LINOTYPE IMPROVEMENT INFORMATION SHEET

NO. 263

AUXILIARY SHIFT KEYBUTTON DEVICE

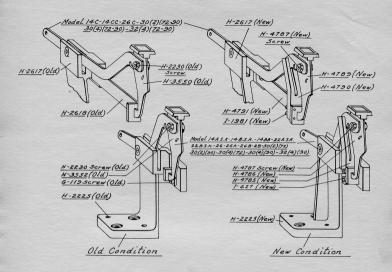
The auxiliary shift keybutton bracket has been strengthened by adding a rib and a guide has been provided for the auxiliary shift keybutton lever. These improvements provide a stronger and more rigid construction of this mechanism.

Can be applied to outstanding Models 14ASK, 14BSK, 14BB, 22ASK, 22BSK, 26, 26A, 26B, 28, 30(2)(72), 30(2)(90), 30(4)(72), 30(4)(90), 32(4)(90) by substituting new H-2225 and H-4786, H-4787; add one of H-4785 and two each of I-627. For Models 14Q, 140C, 26C, 30(2)(72-90), 30(4)(72-90), 32(4)(72-90), substitute new H-2617, and H-4787, H-4789, H-4791, add one of H-4780 and two each of I-1981.
